## Agenda Item # 1 - HOLDOVER MOD-003422-2025

600, 700 & 800 West I-65 Service Road South

- Modification of a previously approved Planned Unit Development

REQUEST PUD Modification

## SITE PLAN

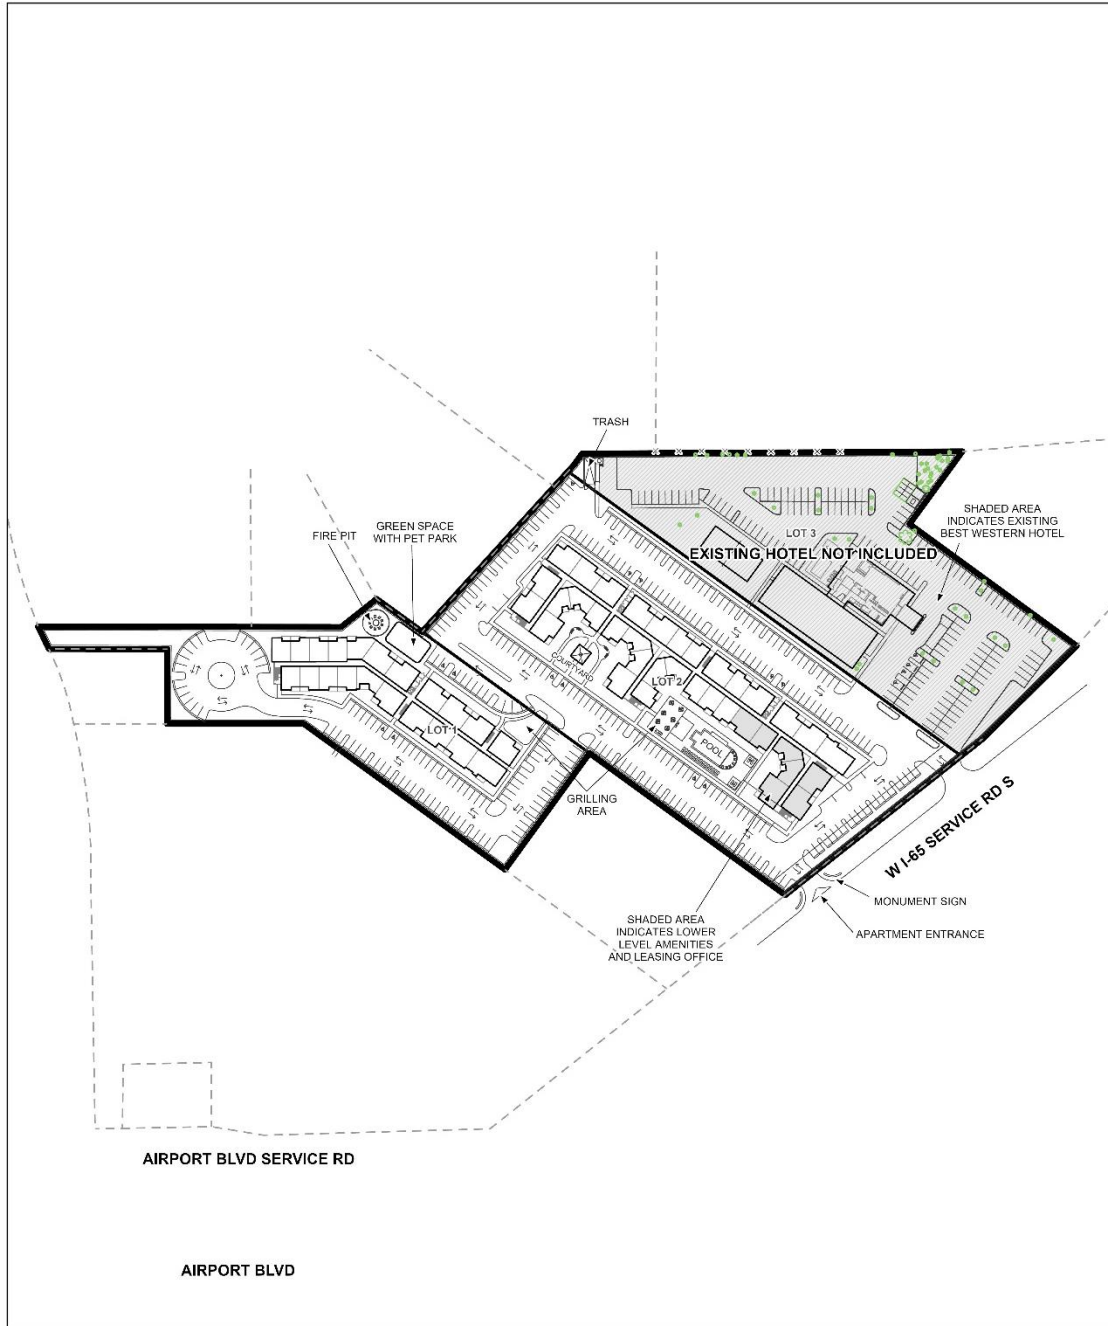
A 25-foot front yard setback is illustrated along West I-65 Service Road South, in compliance with Article 2, Section 64-2-14.E. of the UDC, and should be retained on the Final PUD Site Plan, if approved.

Per Table 64-3-12.1 of Article 3 of the UDC, 1.5 off-street parking spaces per dwelling unit are required, necessitating 326 spaces for the 217-unit development. The site plan indicates 329 proposed off-street parking spaces for the multi-family units; however, the number of spaces provided for the existing hotel is not noted. If approved, this information should be included on the Final PUD Site Plan.

A note on the site plan references “7 Bike Rack,” but no additional information is provided regarding bicycle parking. The parking table does not include bicycle parking, nor does the site plan indicate the location of the rack(s). The plan should be revised to demonstrate compliance with bicycle parking standards of Article 3, Section 64-3-12.A.9, including minimum quantities and required locations.

No building elevations were submitted. Per Section 64-3-6 of Article 3 of the UDC, proposed buildings must include at least one feature from each of the following design categories:

A tree planting and landscape plan was submitted, but it does not demonstrate compliance with the frontage landscape area requirements. The site plan indicates a total site area of 280,648 square feet, requiring 42,097.2 square feet of landscape area (15%), with 60% (25,258.32 square feet) located between the street-facing property line and the nearest building(s). Only 5,408 square feet of front landscape area is proposed. This shortfall may be considered via the Major Modification process upon request and justification by the applicant; otherwise, the site plan must be revised to comply.

The landscape plan also does not demonstrate compliance with the area, dimension, and canopy standards of Article 3, Sections 64-3-7.A.7 and 64-3-7.A.8.

As noted, a trash compactor is shown on the site plan. A note references compliance with the dumpster enclosure and placement standards of Section 64-3-13.A.4 of the UDC. This note should be retained on the Final PUD Site Plan, if approved.

1. Label the drawing that was submitted (Sheet No. A0.2) as the PUD Site Plan.
2. Label all of the NEW or EXISTING buildings, structures, parking areas, trash receptacles, apartments, etc.
3. Label the existing public roadways.

***Revised for the September 18<sup>th</sup> meeting:*** *This proposed design does not meet adopted fire access requirements. The possible emergency access only drive will be required.*

The site plan appears to depict a modification to the existing property line between Lot 2 and Lot 3. While this may reflect the revised PUD boundary, any alteration to property lines within an approved PUD must be consistent with the underlying subdivision. Therefore, re-subdivision is required to formalize such changes. If this is the case, the application must be held over until a Subdivision application is submitted for concurrent review by the Planning Commission, in accordance with Article 5, Section 64-5-1.D. of the Unified Development Code (UDC).

It is unclear whether curbing or wheel stops are included where vehicles may extend beyond parking spaces. This should be noted on the revised site plan, or the Final PUD Site Plan should be updated to illustrate wheel stops and pedestrian walkways connecting each parking area to the respective buildings.

Recent aerial imagery indicates a sidewalk was constructed along West I-65 Service Road; however, it is not shown on the site plan. Additionally, no pedestrian walkways from the sidewalk to the proposed buildings are illustrated, which is required under Article 3, Section 64-3-3 of the UDC. Upon approval, the existing sidewalk and all required pedestrian walkways must be shown on the revised site plan.

Bicycle parking is neither depicted nor addressed on the parking table. The site plan should be revised to comply with bicycle parking standards outlined in Article 3, Section 64-3-12.A.9. of the UDC, including minimum quantities and location requirements.

Two-way traffic circulation is proposed, requiring 24-foot-wide drive aisles per Table 64-3-12.2. Due to the current scale, compliance cannot be verified. The site plan should be revised to show drive aisles with a minimum width of 24 feet, unless the design is reconfigured for one-way circulation, which requires a minimum 14-foot width.

1. Revision of a note on the site plan stating "Existing Hotel Site Not Included" to state "Existing Hotel Site," or some other variation;
2. Retention of the 25-foot front yard setback along West I-65 Service Road South;
3. Provision of lot sizes for each lot in square feet and acres, either directly on the revised site plan or via a table on the site plan;
4. Revision of the site plan to depict compliance with bicycle parking requirements, pursuant to Article 3, Section 64-3-12.A.9. of the UDC;
5. Retention of a note on the revised site plan stating that the site will comply with parking lot lighting standards under Article 3, Section 64-3-9.C. of the UDC, and that a photometric plan will be submitted at the time of permitting;
6. Retention of each building size in square feet on the revised site plan, or provide a corresponding table with the same information;

7. Provision of building elevation drawings demonstrating compliance with Article 3, Section 64-3-6 of the UDC, or placement of a note on the revised site plan stating that each new building will comply with these standards;

8. Revision of the site plan to illustrate compliance with tree planting and landscape area requirements of Article 3, Section 64-3-7 of the UDC, or placement of a note stating that a landscape plan compliant with these requirements will be submitted at the time of permitting;

9. Revision of the site plan to demonstrate compliance with the frontage landscape area requirements of the UDC, or obtain approval from the Planning Commission and City Council for a reduced front landscape area;

***Revised for the September 18<sup>th</sup> meeting: Retain PUD SITE PLAN NOTES a - f as shown on the PUD SITE PLAN.***
